# CK3 Single Dock Schematic

CK3 SD Charger  
Revision: D3  
Date: 01/01/2018  
Author: CYW  
Step: 1 of 1

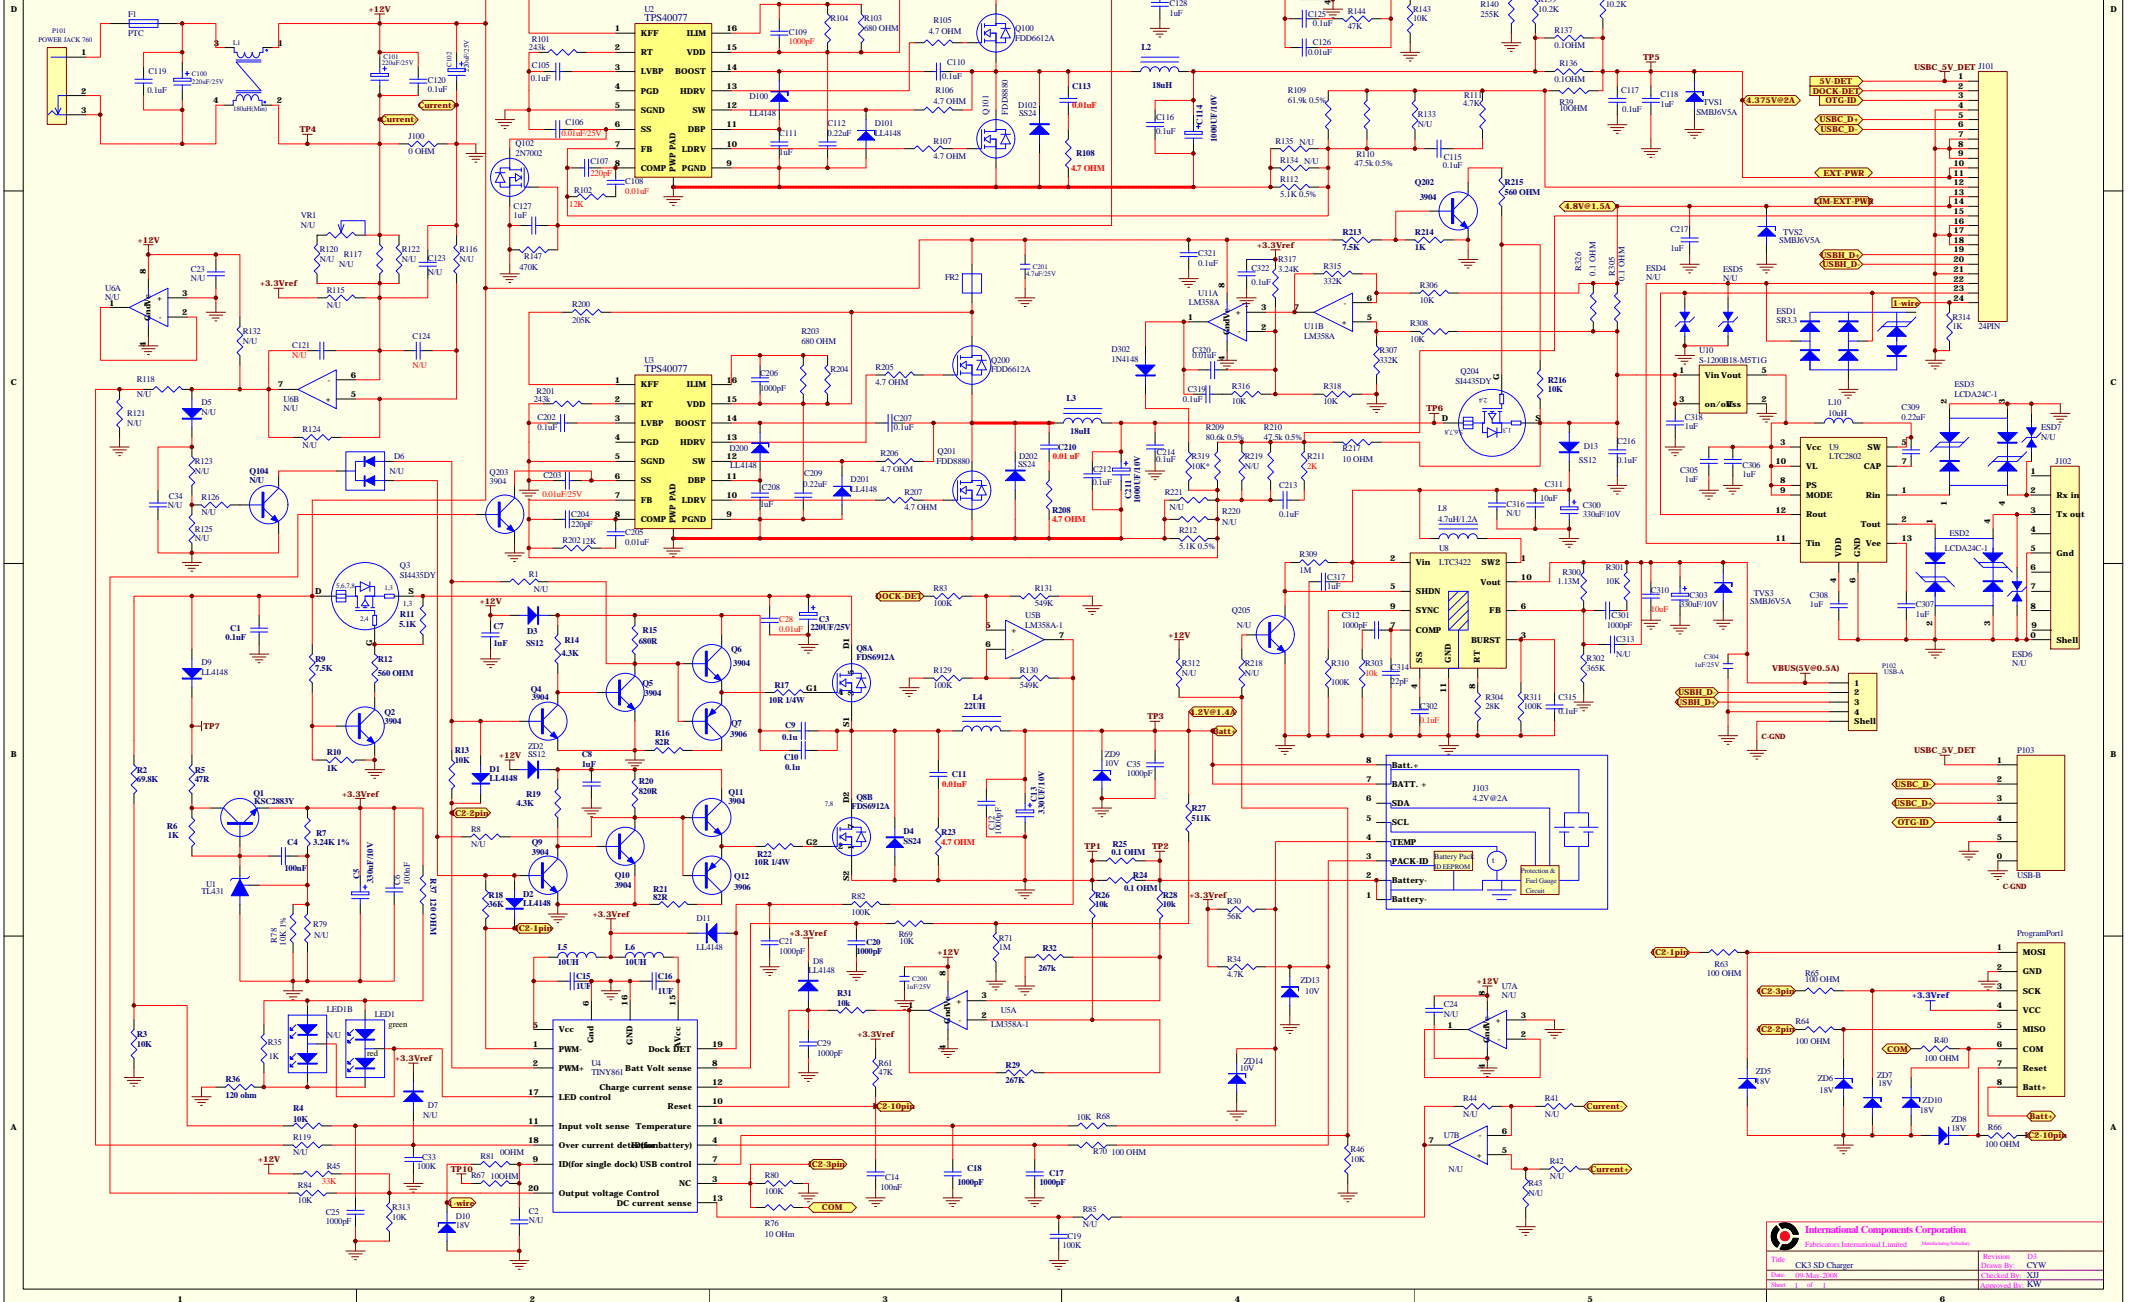
VerD3: From D2 to D3  
1: R316 value change from 47K to 10K  
2: remove Q205, R218.
